ADDENDUM NO.1 – OCTOBER 20, 2020

Job Name
USC AIKEN SCHOLARS ACADEMY MAINTENANCE BLDG
TSC20-45470
471 UNIVERSITY PKWY, AIKEN SC

USC AIKEN - REPURPOSE
432 SCHOLAR LOOP
AIKEN, SC 29801
GMC # AC0180012
OSE # H29-9555
BID DOCUMENTS

DETAILS, NOTES, SCHEDULES, AND LEGEND
M3.01

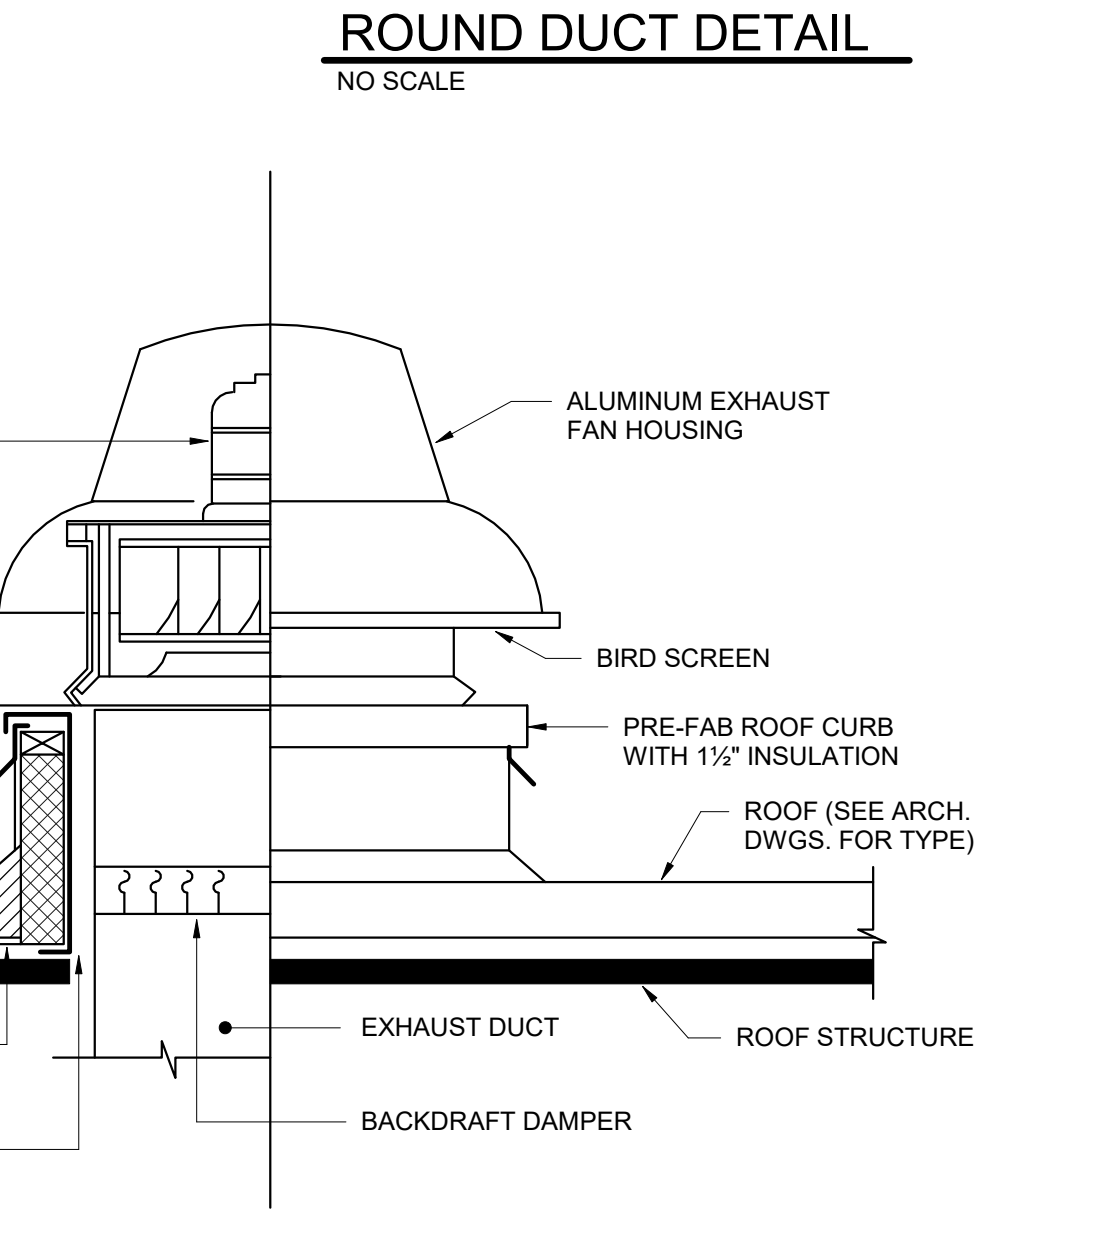
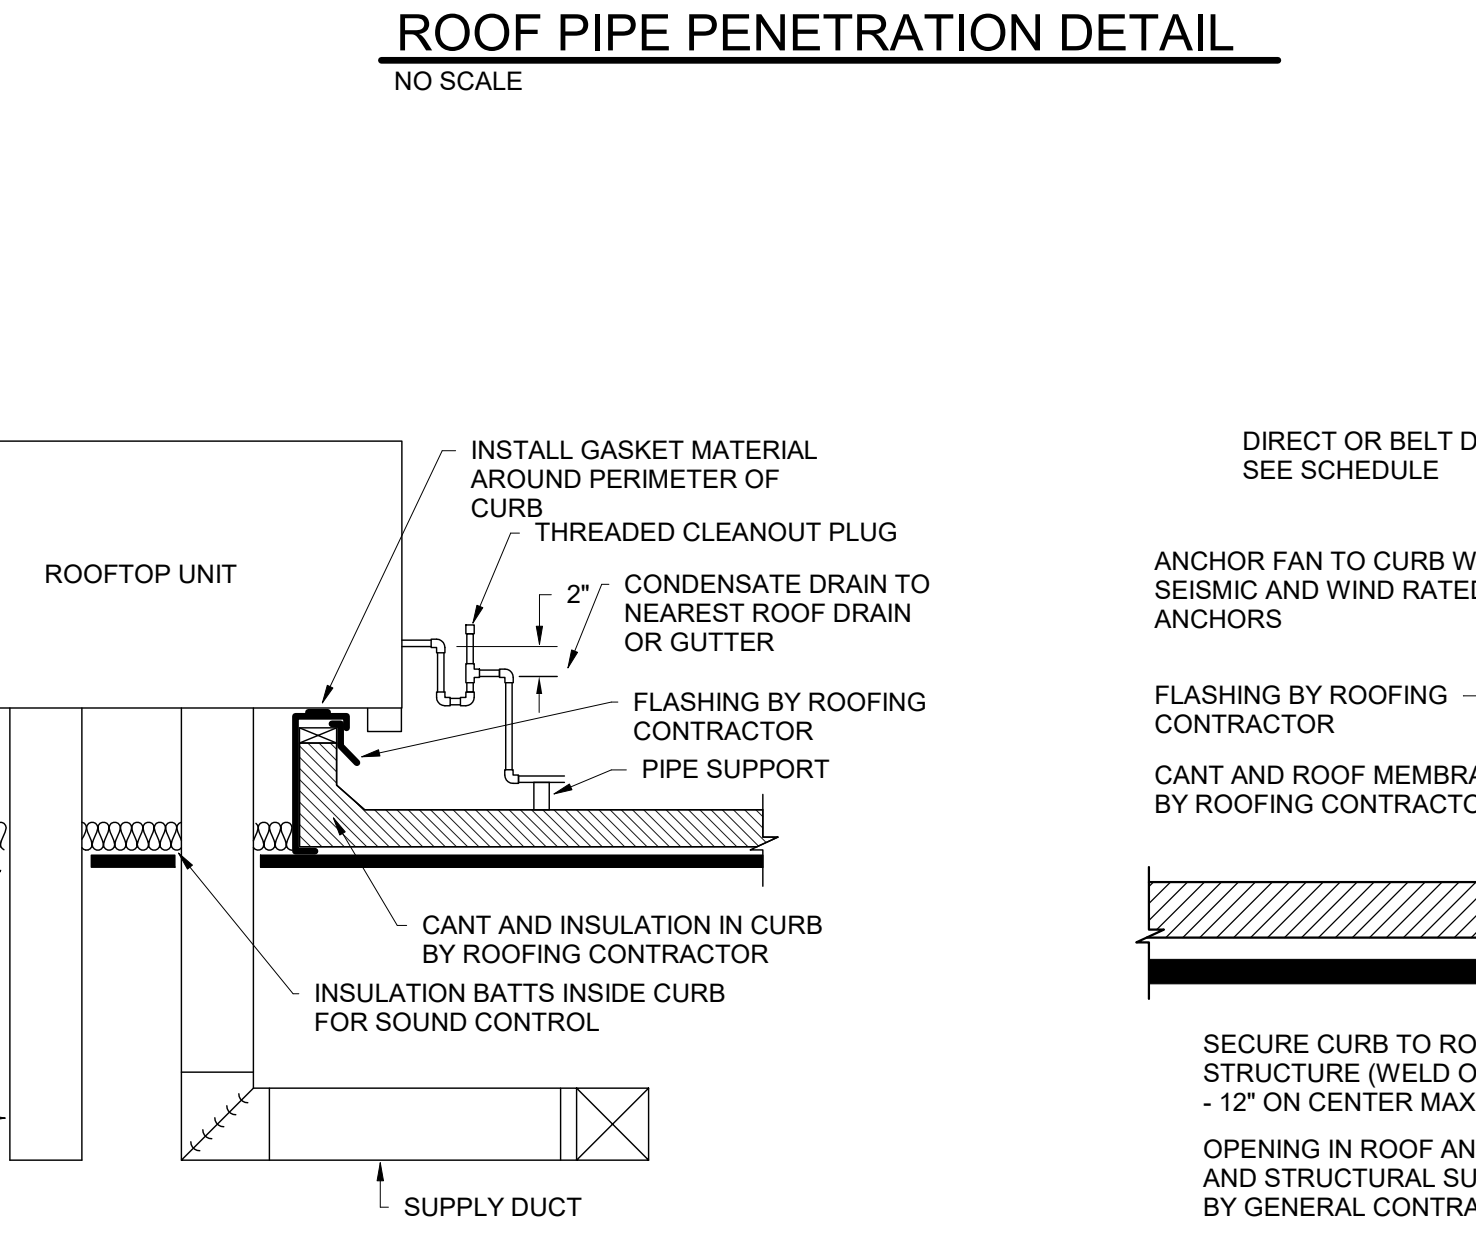
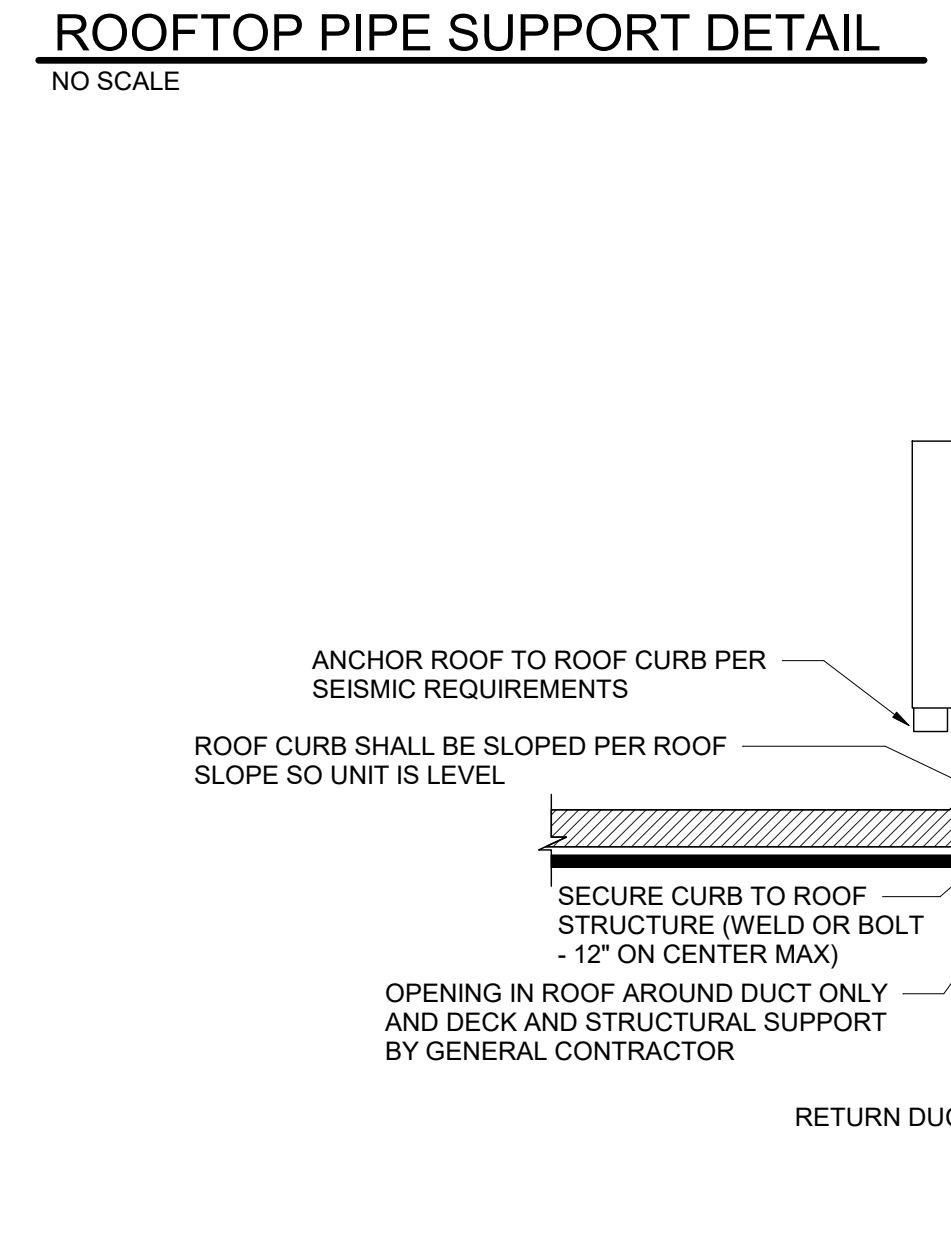
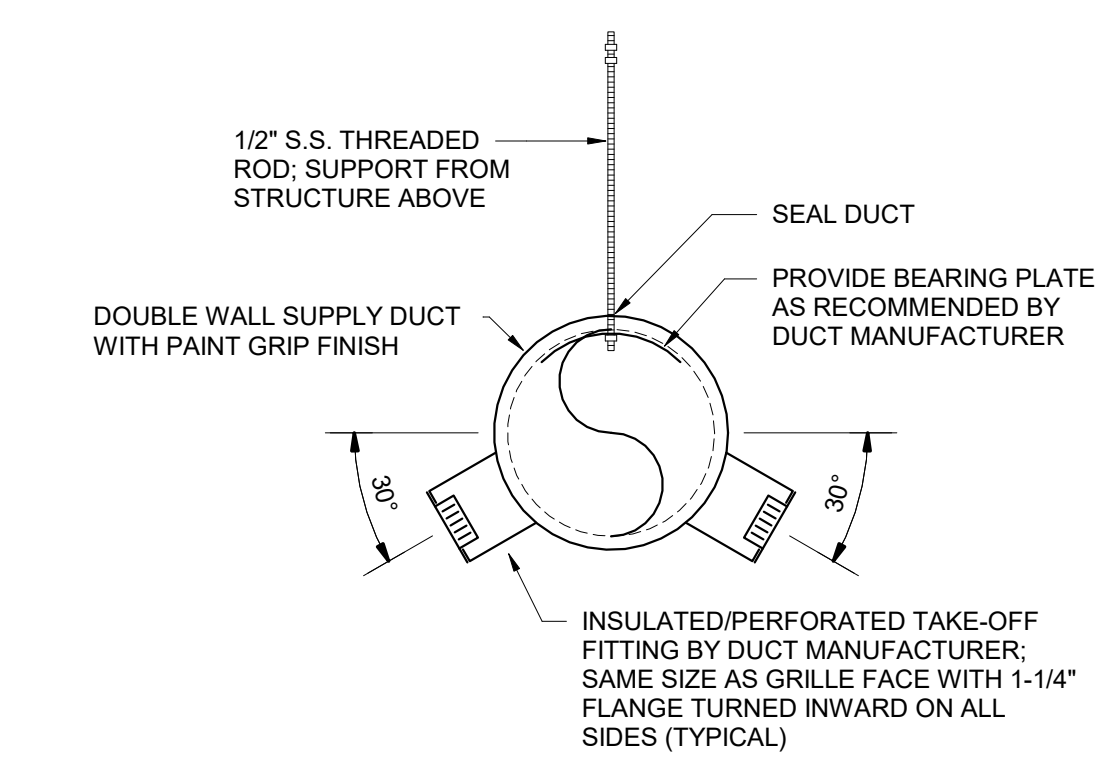
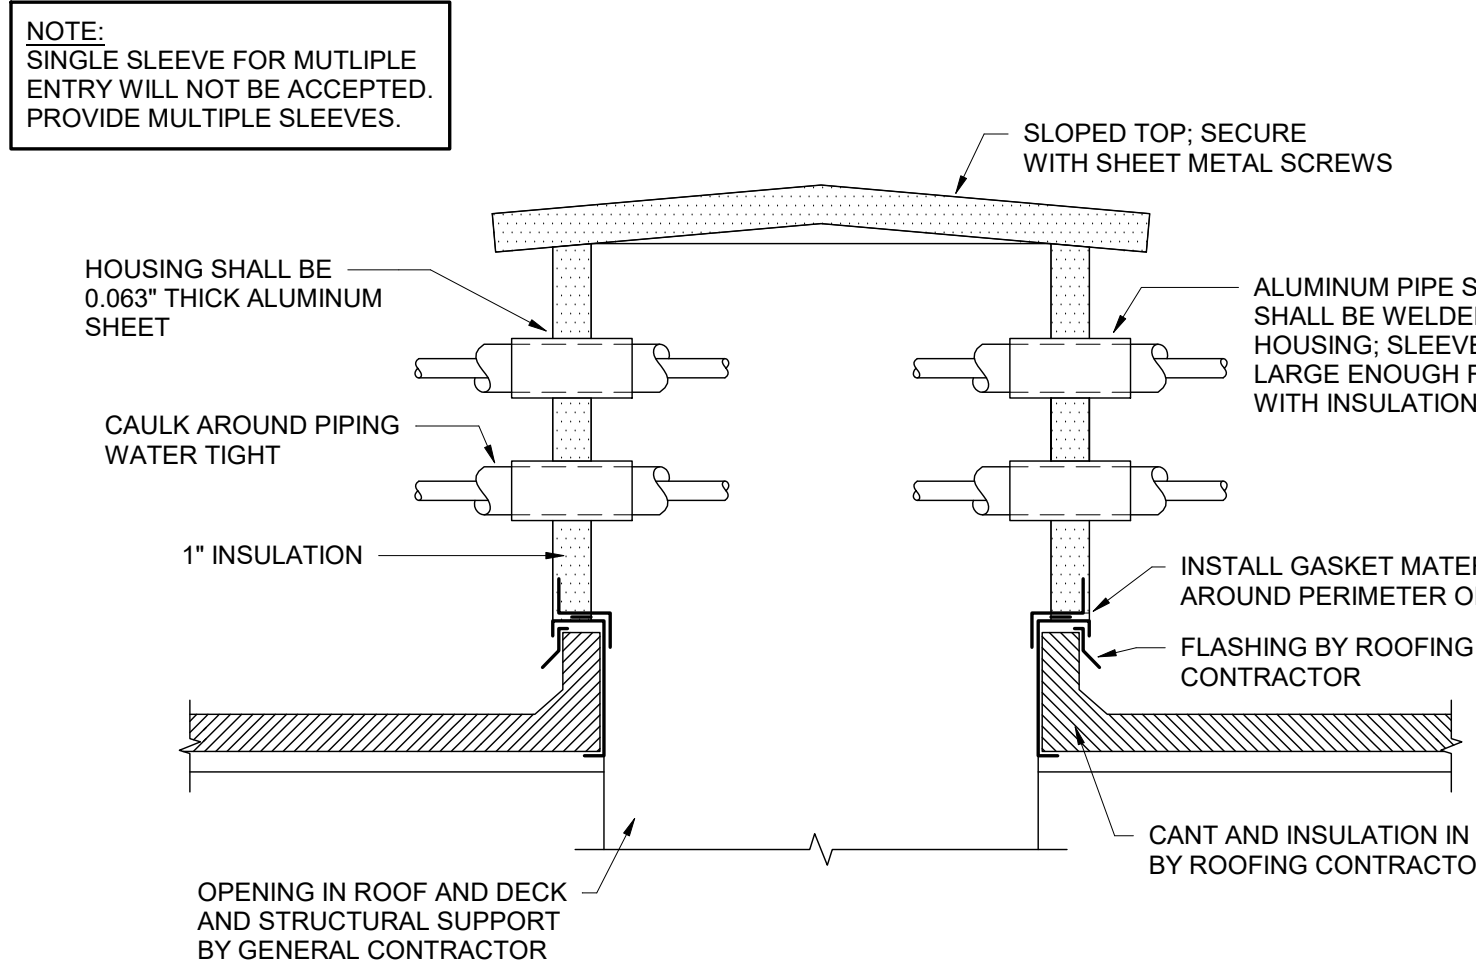
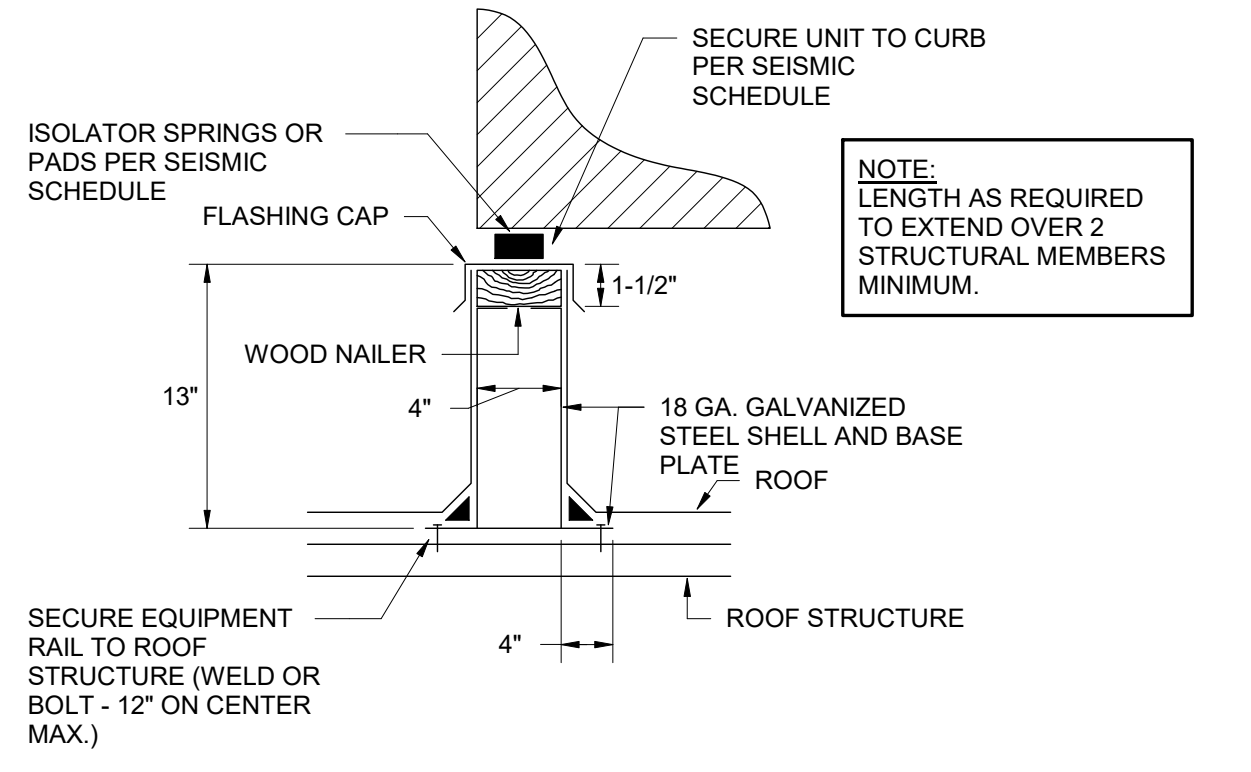
- M3.01 Sheet M3.01 Replace sheet in its entirety and replace with attached sheet M3.01 Reference Series Fan Powered Variable Volume Box Schedule and Variable Volume Box Schedule. VAV terminal tags for RTU-2 have been modified.
- E0.02 Sheet E0.002 – A substitution request has been submitted to the A/E for lighting fixtures and is approved with the following comments (see attached): The submitted fixtures are pre-approved equals as follows:
1. All submitted fixtures are approved including:
 - a. Type A2/A2E Option 1
 - b. Type A4/A4E Option 1
